CONSIDERATION OF AND/OR ANY APPROPRIATE ACTION ON PANORAMA STREET PRELIMINARY PLAT, SITUATED IN THE PHILLIP ANDERSON SURVEY, ABSTRACT NO. 10 CITY OF PARKER, COLLIN COUNTY, TEXAS. [MACHADO]

Re: Panorama Street
 Preliminary Plat and Engineering Plan Review

As you requested, we have reviewed the Preliminary Plat & Engineering Plans for the Panorama Street Addition prepared by LJA Engineering, Inc. These documents include a new street and is therefore considered a major subdivision under section 155.025 of subdivision ordinance.

PAVING DETAILS

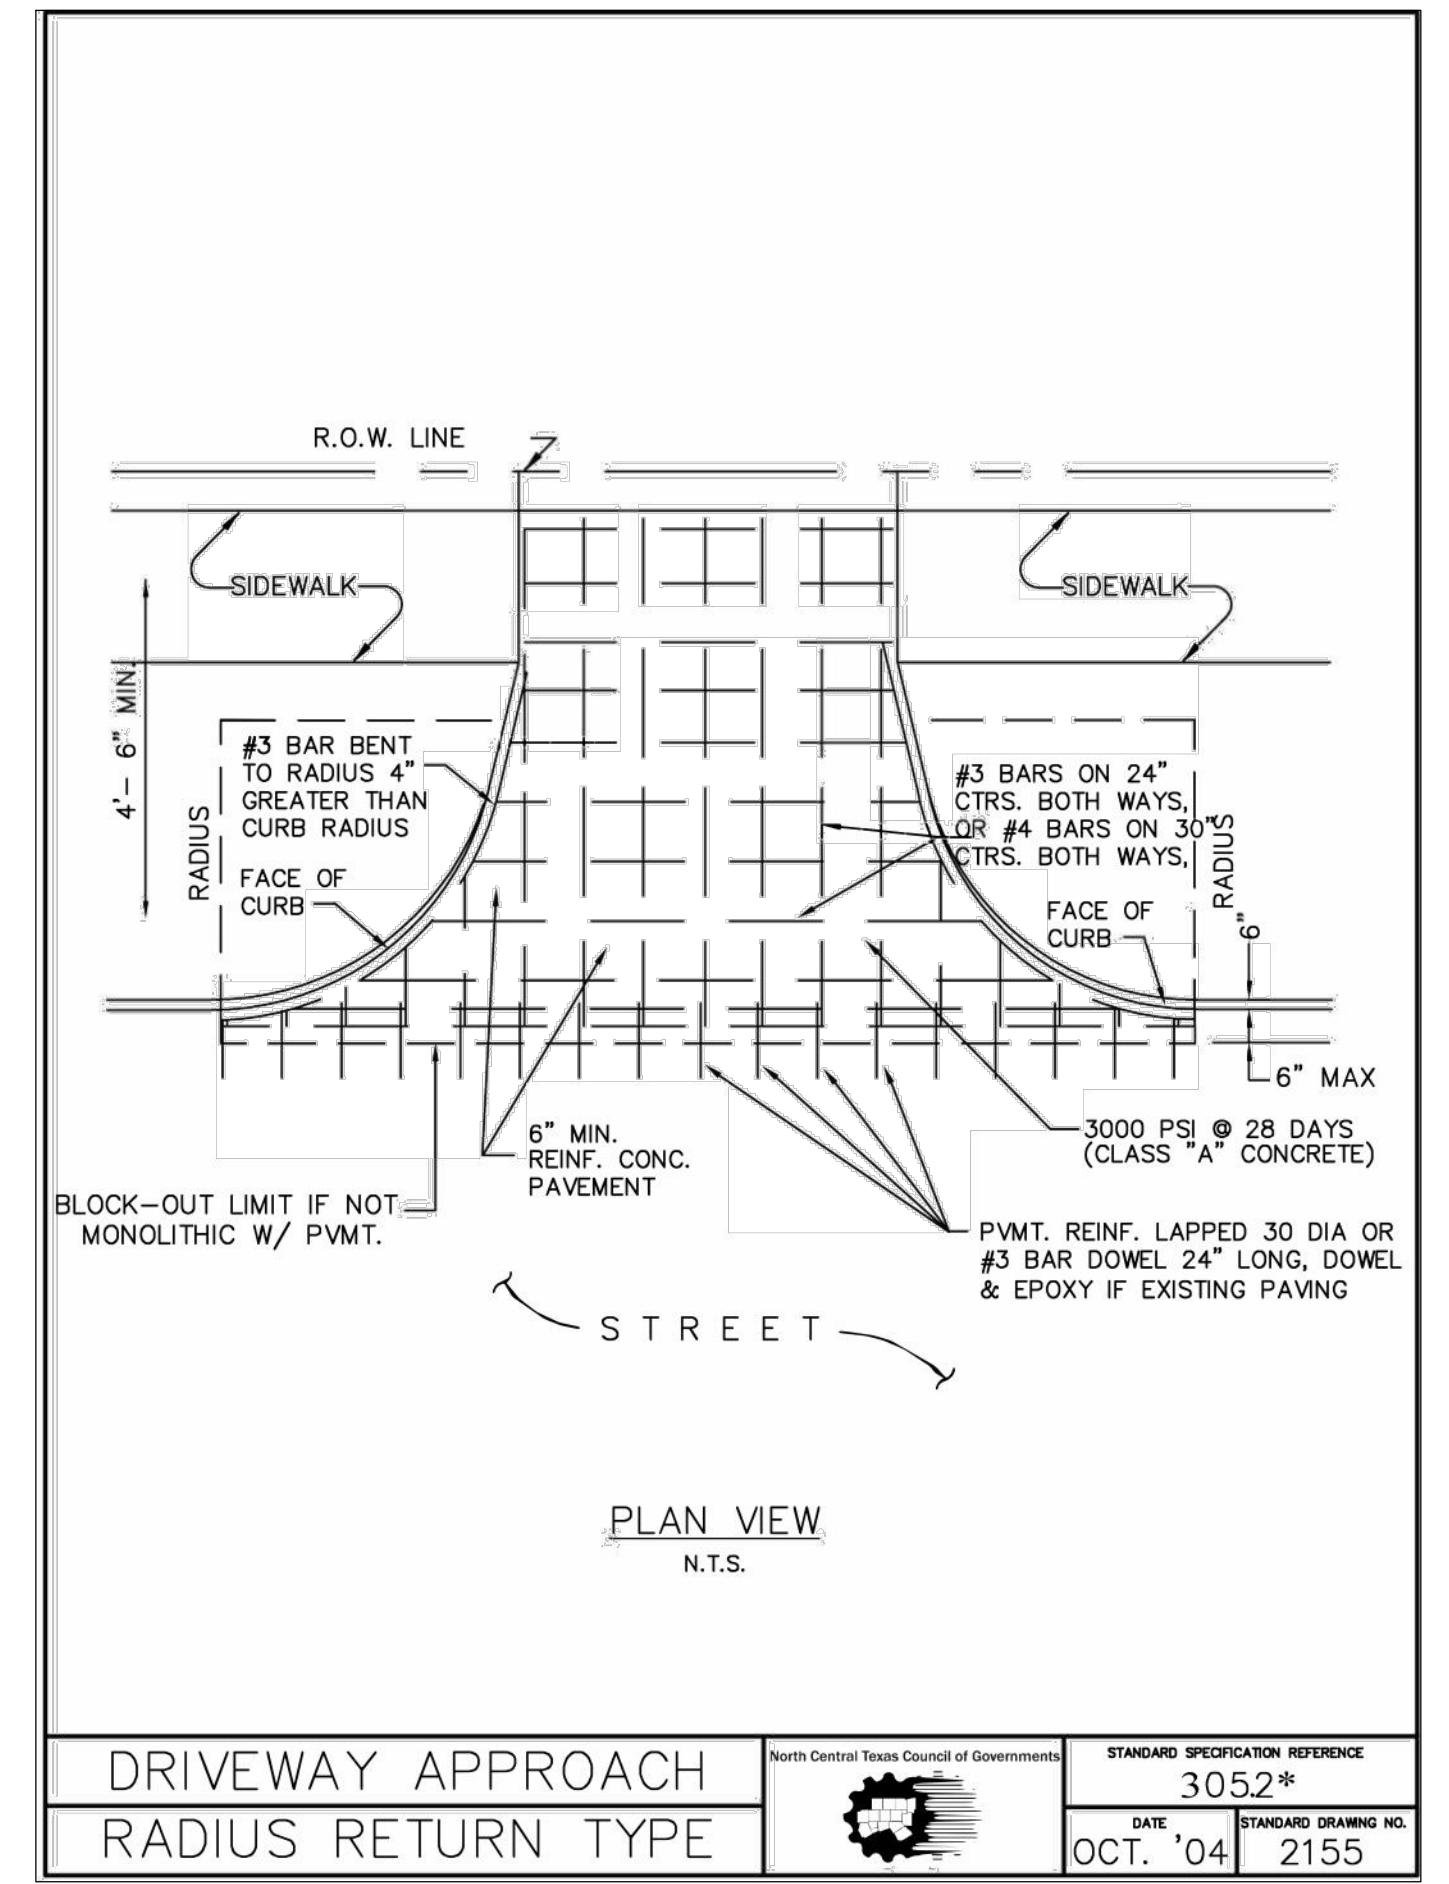
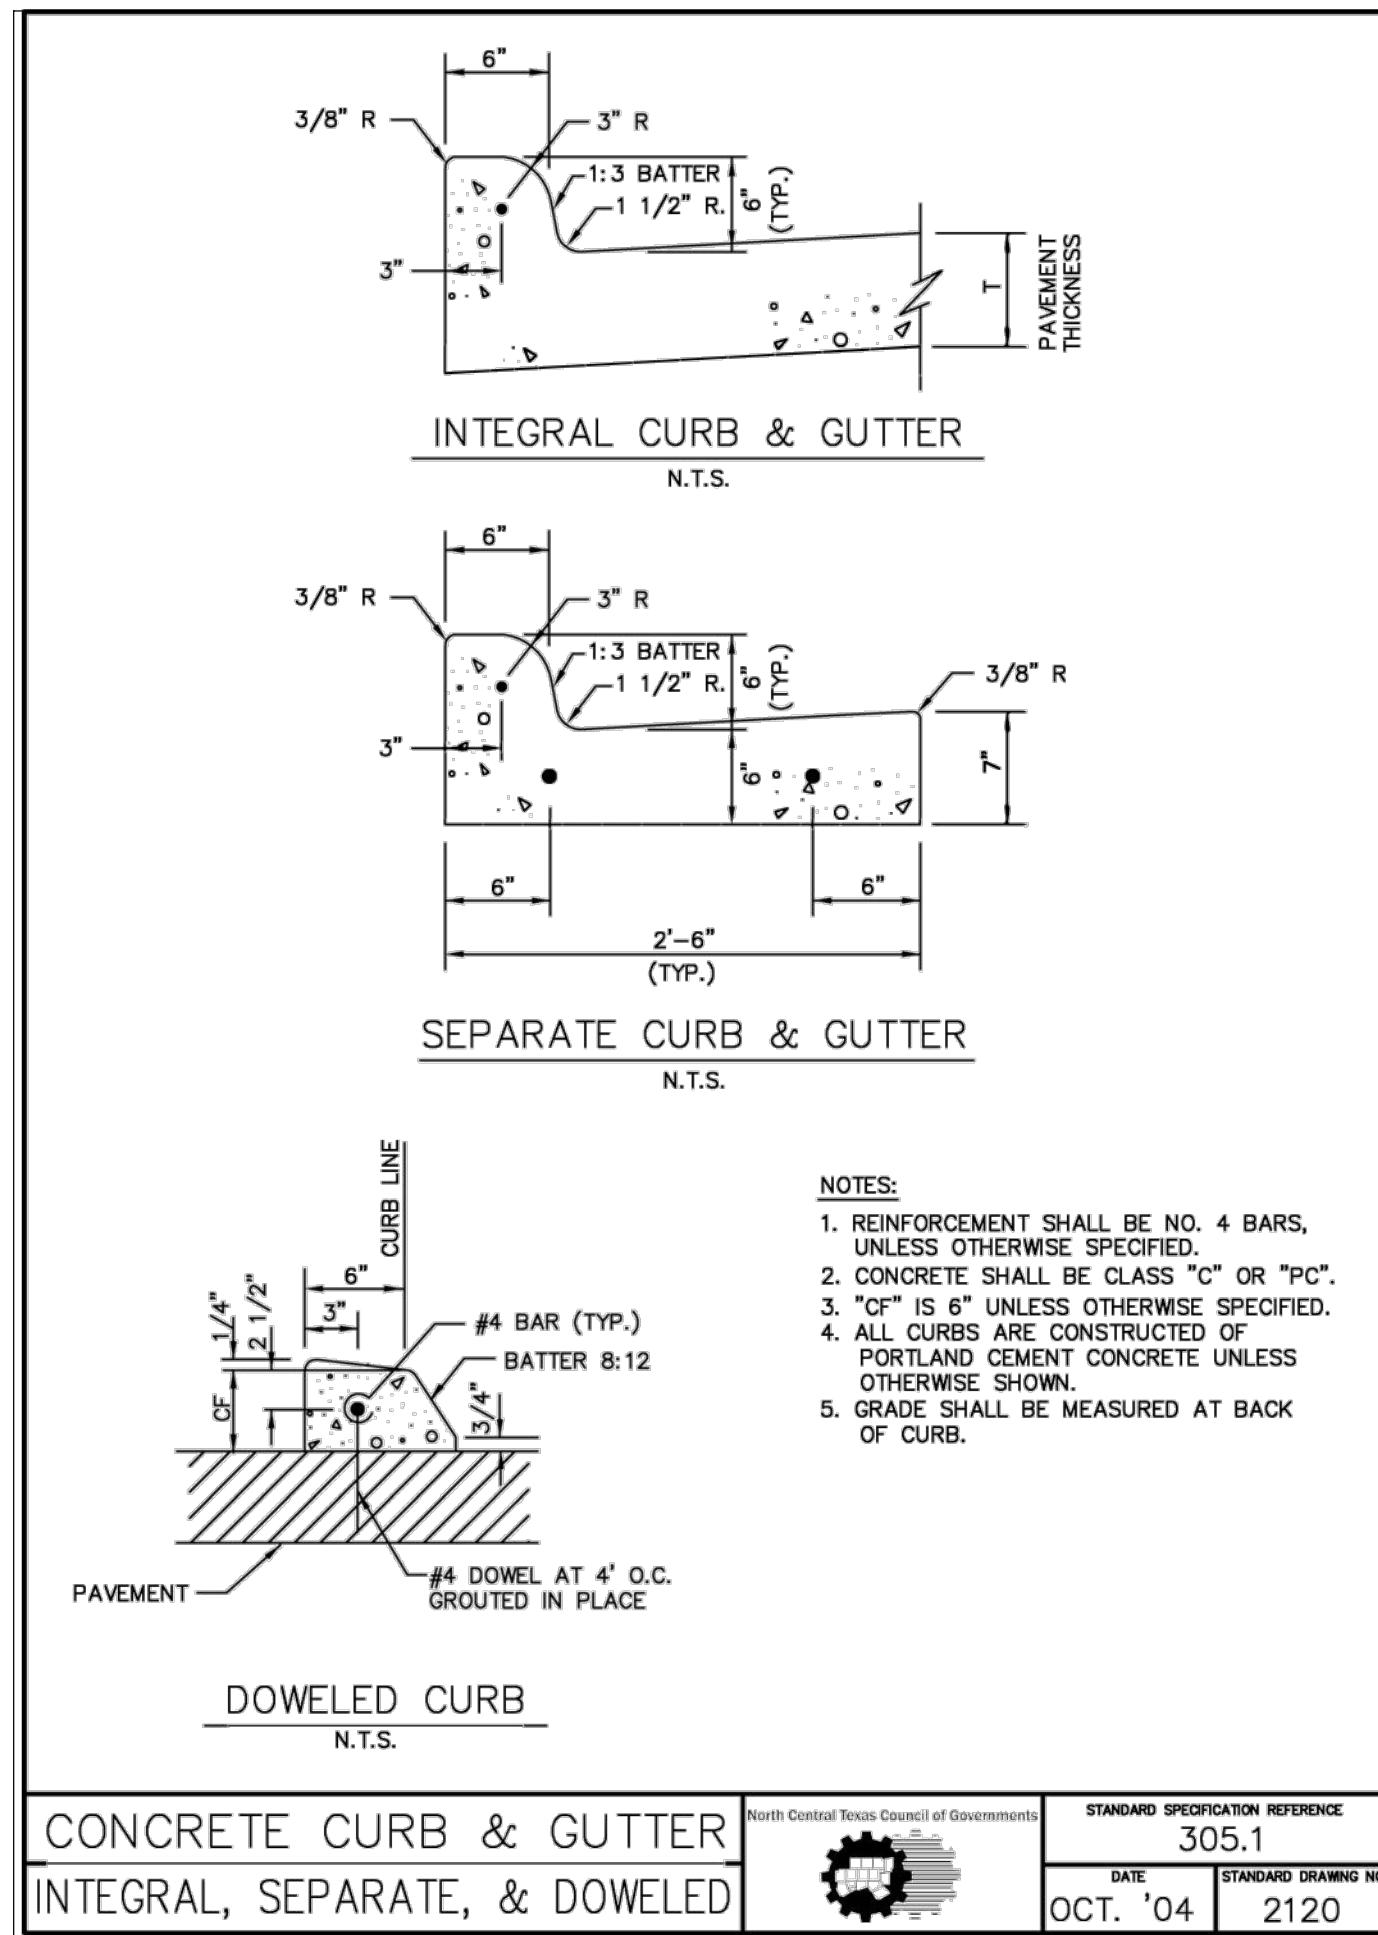
90. Sheet 34 Driveway approach and Street Headers at railroads do not apply. There are no driveways proposed off the street and there are no railroads in the City of Parker.
